RE: Former Parkway Cleaners
NYSDEC Site #: C835028
47 Eastern Boulevard
Canandaigua, New York

Addendum #1 to Interim Remedial Measures Work Plan for Mitigation of Potential Soil Vapor
Intrusion dated February 2019

PROJECT TITLE	DRAWING TITLE
FORMER PARKWAY CLEANERS BCP SITE C835028 CANANDAIGUA, NEW YORK	SSDS: PLAN

FIGURE 1

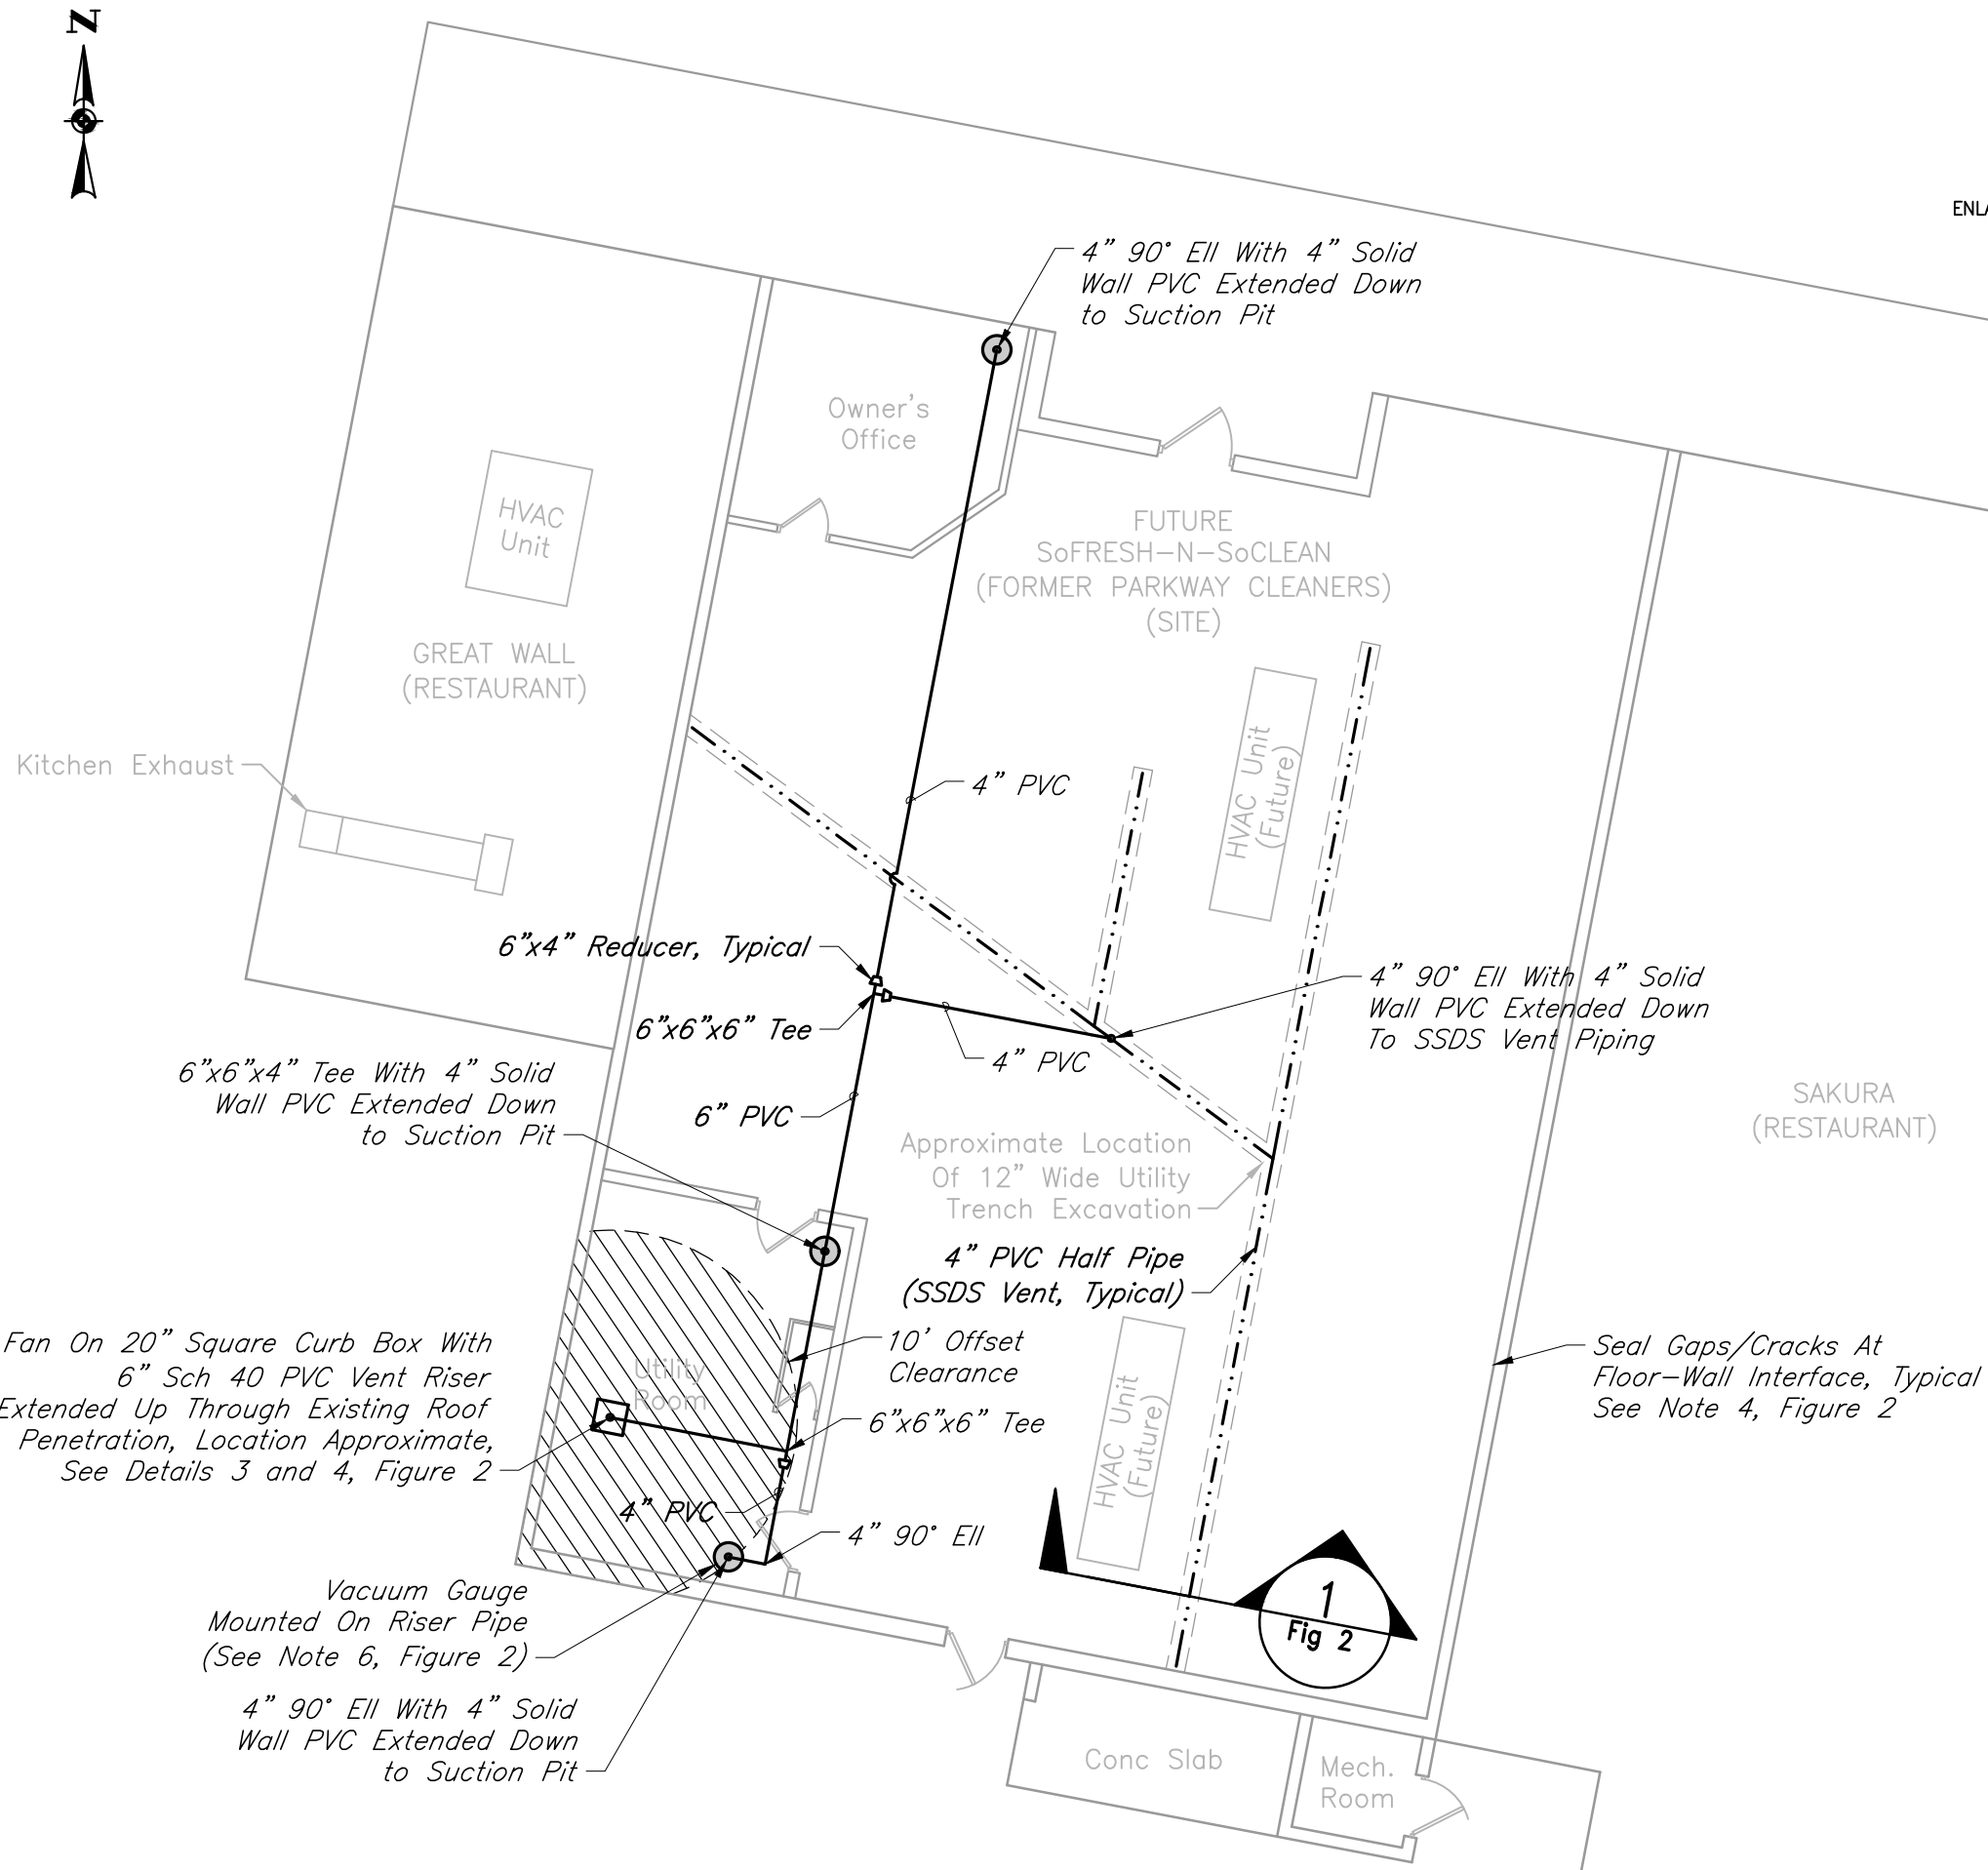
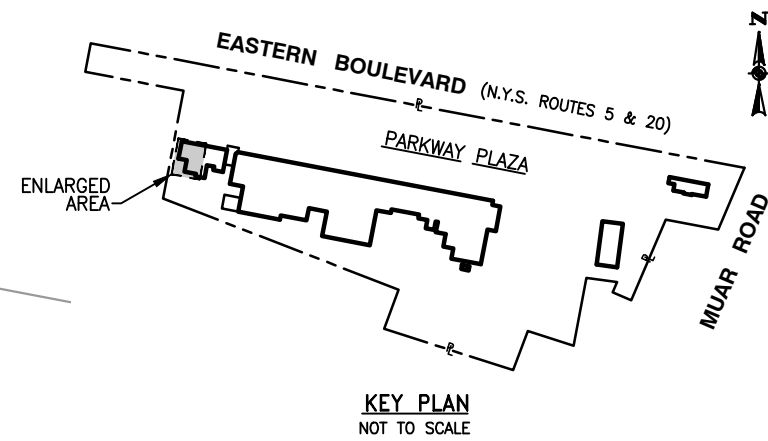
Attached is Addendum #1 to the Interim Remedial Measures Work Plan for Mitigation of Potential Soil Vapor Intrusion dated February 2019 (Work Plan) for 47 Eastern Boulevard, 51 Eastern Boulevard, and 57 Eastern Boulevard, Canandaigua, New York (Site), prepared by Day Engineering, P.C. (DAY). The sub-slab depressurization system (SSDS) site plans, details, sections and notes comprising Addendum #1 have been prepared to notify the New York State Department of Environmental Conservation (NYSDEC) of proposed infrastructure, controls and testing locations associated with the installation and evaluation of the Site specific SSDS. A revised project schedule for the installation and evaluation of the SSDS is also included in Addendum #1.
